Application Note of IT8761F for Power On Strapping Circuit

July 1, 1999

Power on strapping circuit needs extra attention when a "0" setting is selected

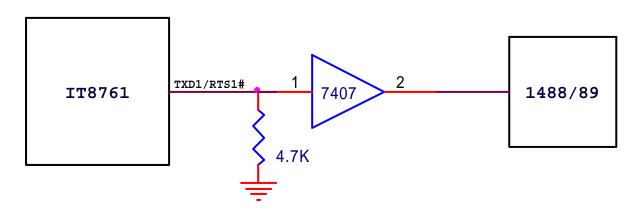
Description: Due to IT8761 Rev. B power on strapping pins selection, a "0"

setting may not be strapped in correctly.

Cause: IT8761 chooses TXD1 and RTS1# pins for power on strapping

> setting, since these two pin also connect to 1488/1489 type line driver and some of the line driver internally have +12V pull up with a 11K ohm resistor, this will cause the "0" setting not

correctly strapped.

- Suggestion: (1) Choose a small enough value pull down resistor to make the strapping line voltage below 0.5V when system is reset. A suggested resistor value is 680 ohm.
 - (2) Implement a redundant gate between IT8671 and line driver to isolate the interfere of the internal pull up of 1488/89 line driver as following circuit.
